KANE NSS.378 / NSS.378-1

ISSUE 7.1

BLOOR HOMES

DRAWING: FIRST FLOOR PLAN

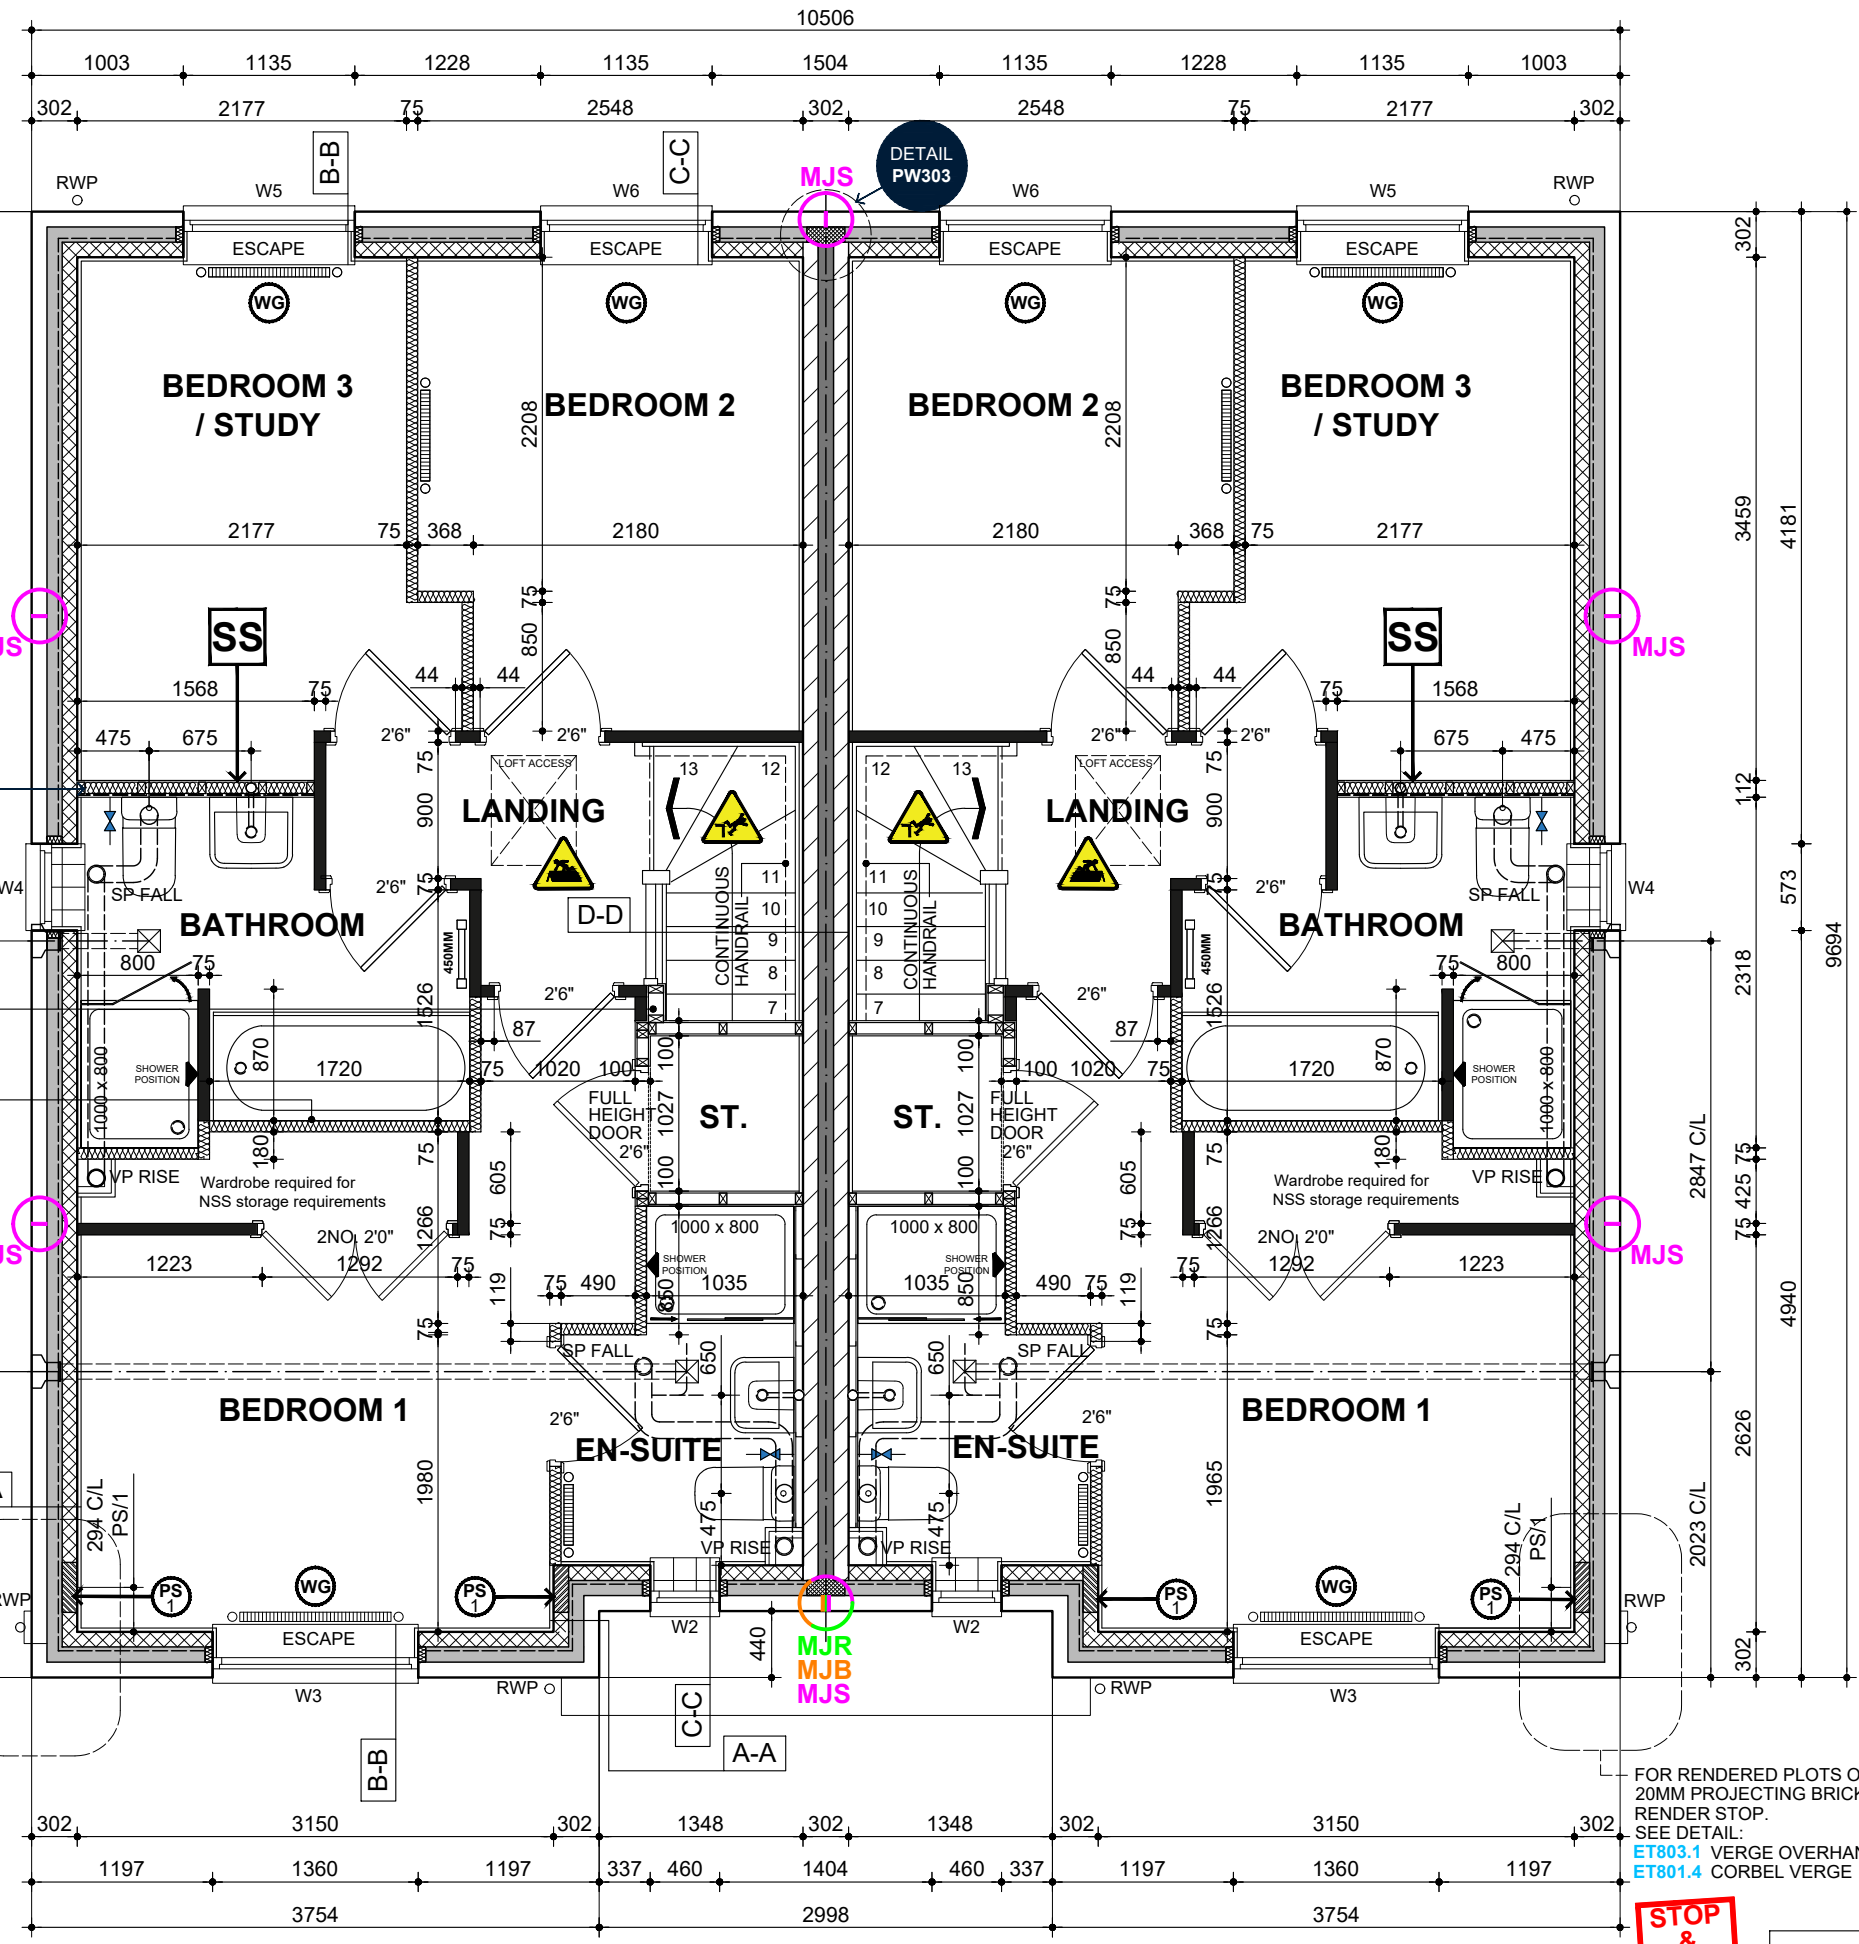
BATHROOM EXTRACT FAN REVISED TO CEILING MOUNTED IN LINE WITH FEEDBACK

DRAWING: CLA BRICK ELEVATIONS

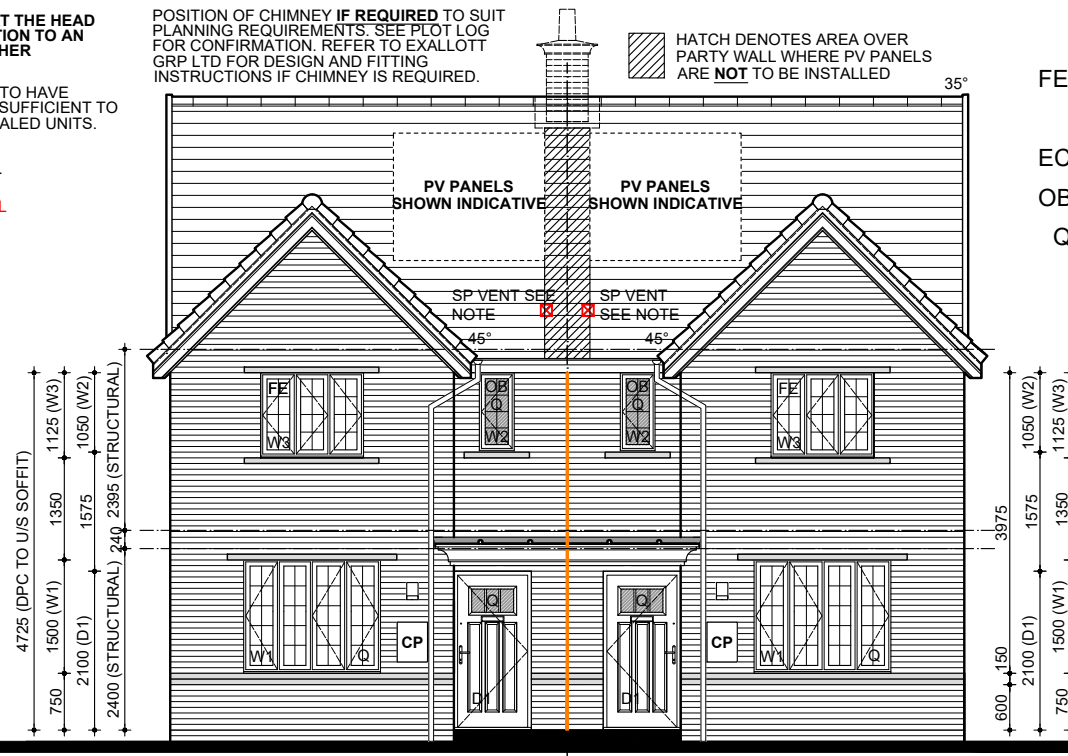
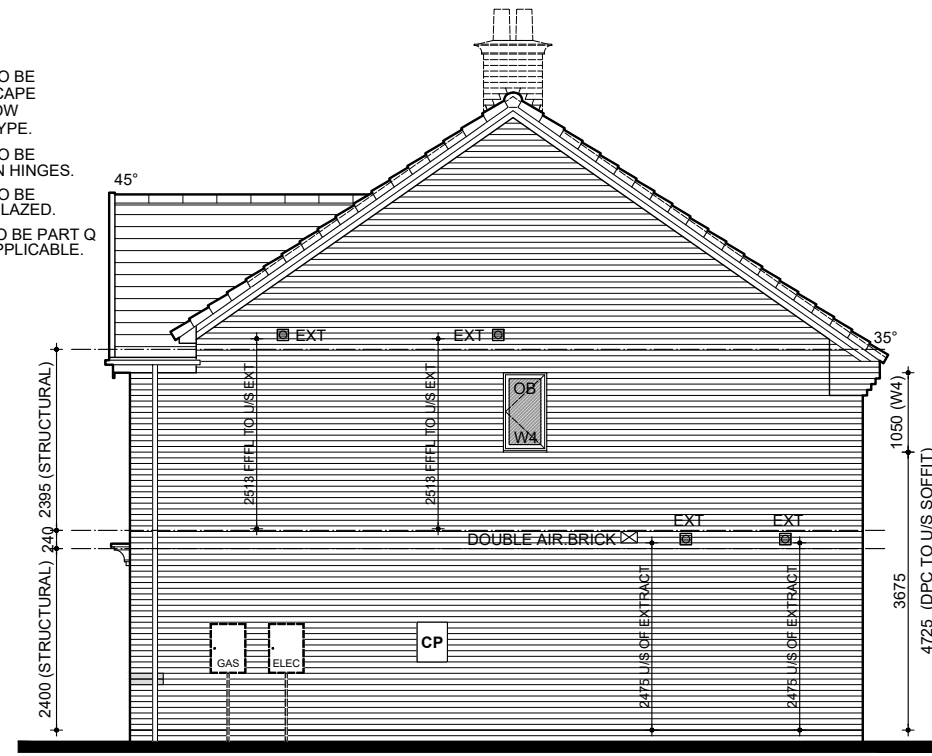
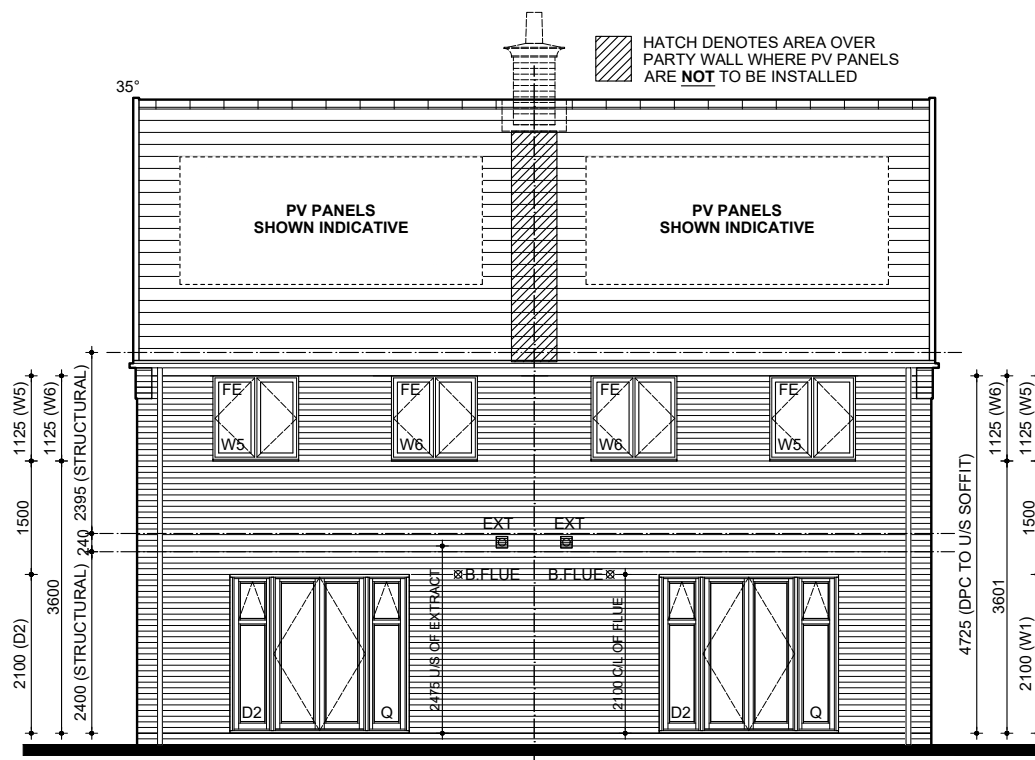
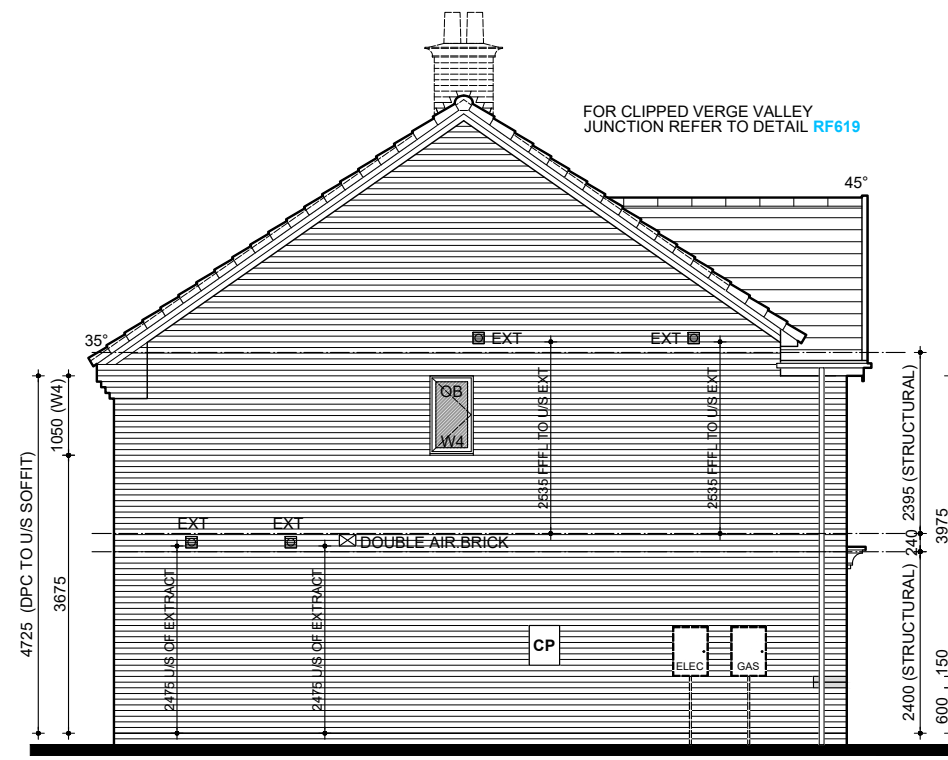
KITCHEN EXTRACT FAN POSITION REVISED AND BATHROOM EXTRACT FAN REVISED TO CEILING MOUNTED IN LINE WITH FEEDBACK. CHECK REVEAL NOTE ADDED TO ELEVATIONS.

DRAWING: SECTION C-C

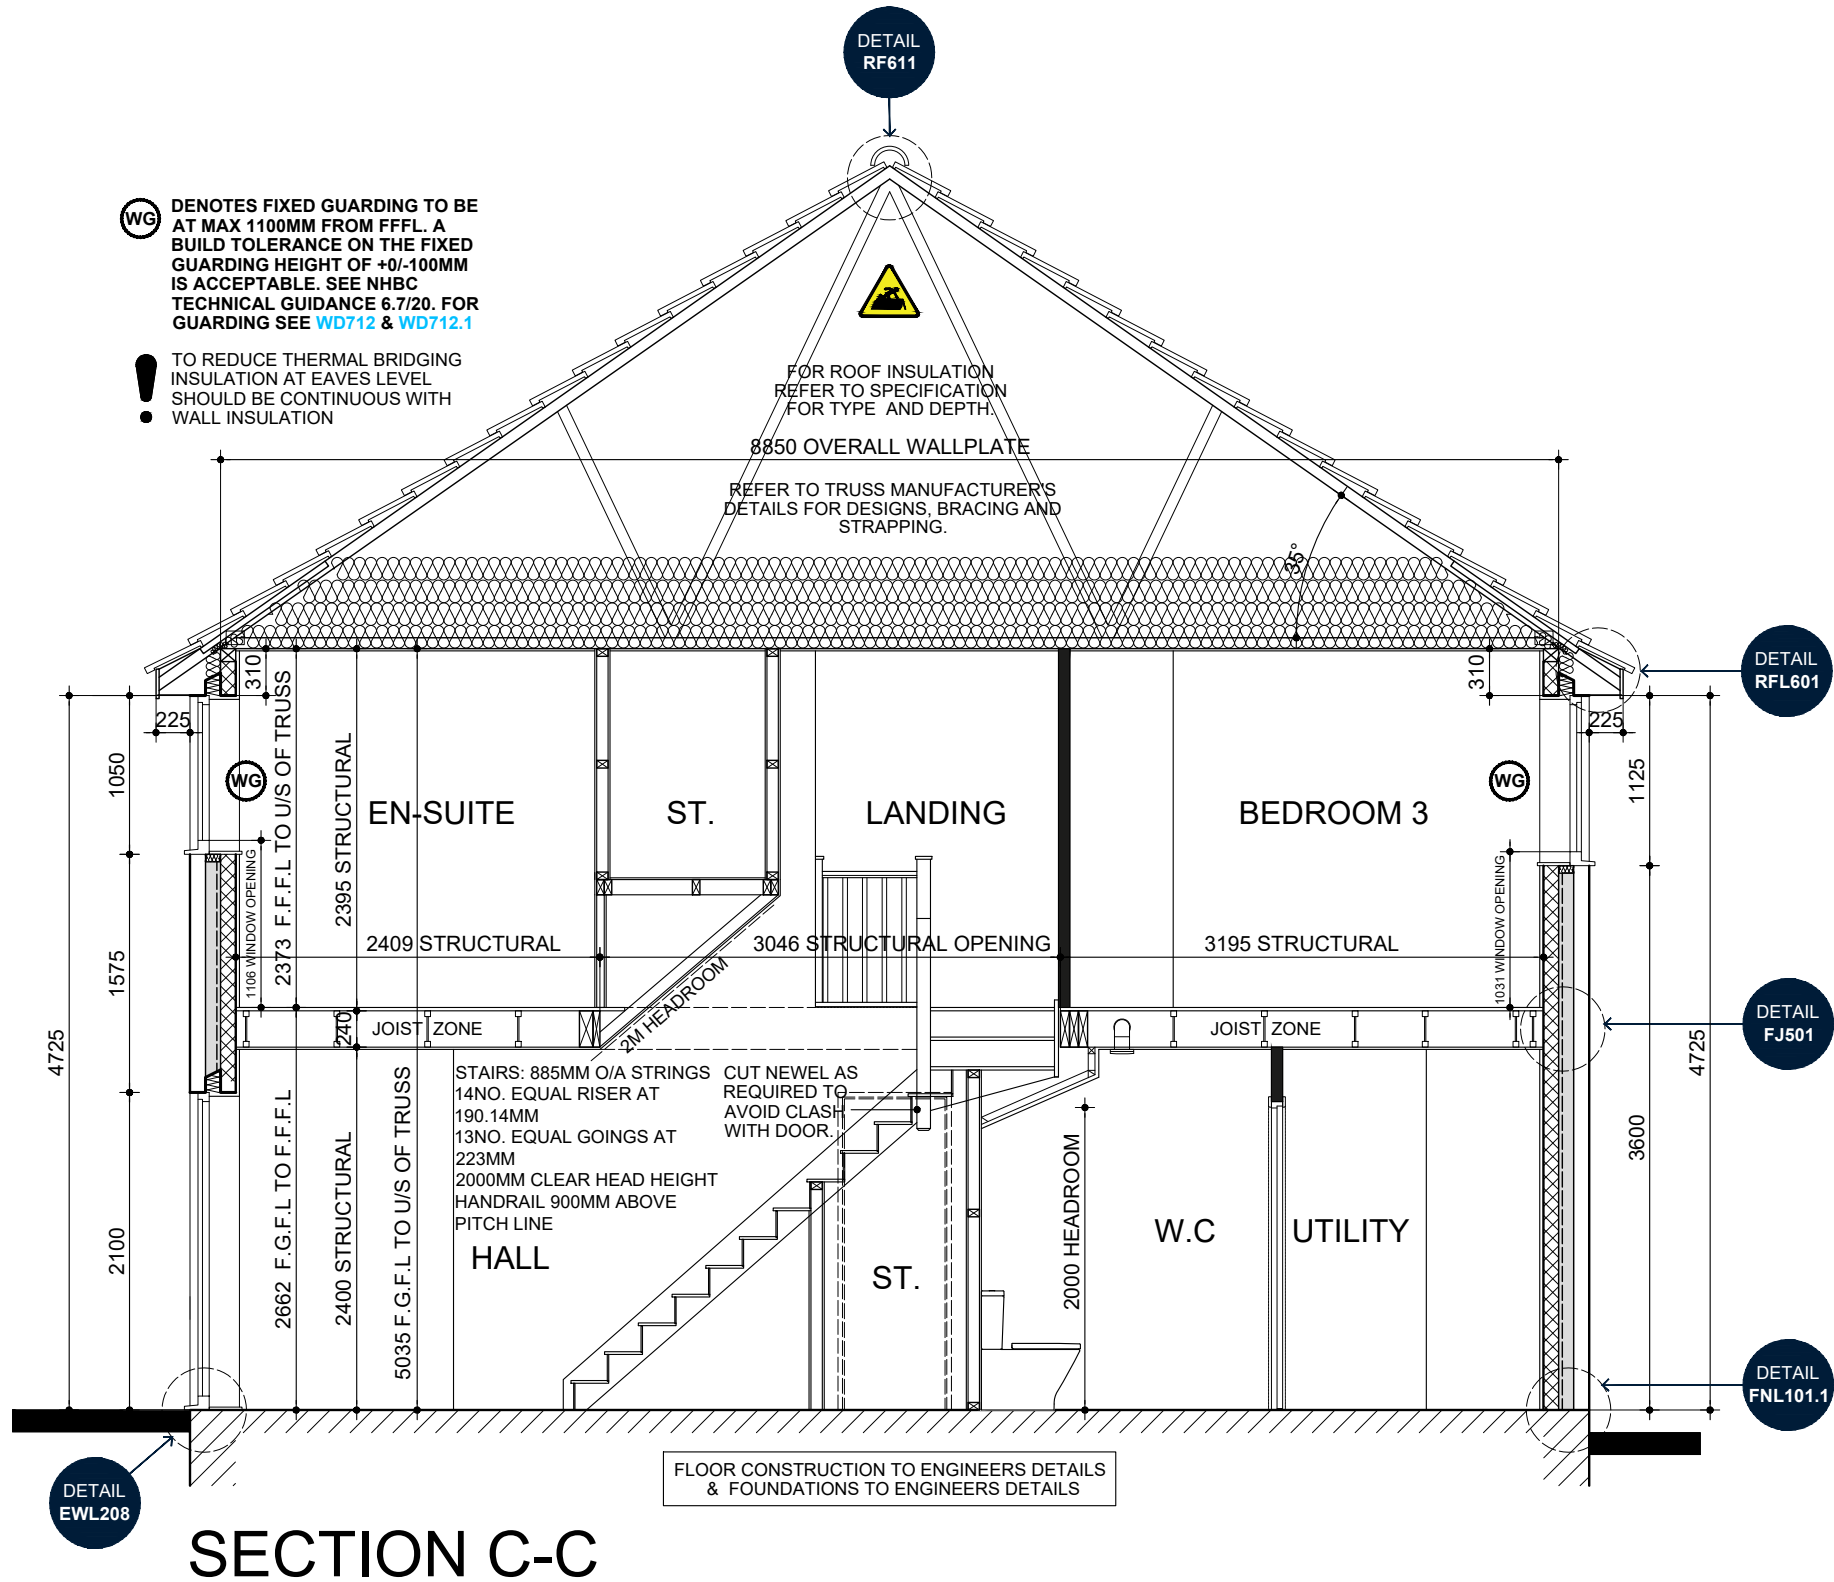
REV: 7
JUNE 2024
EN-SUITE HEIGHTS REDUCED TO 1050MM
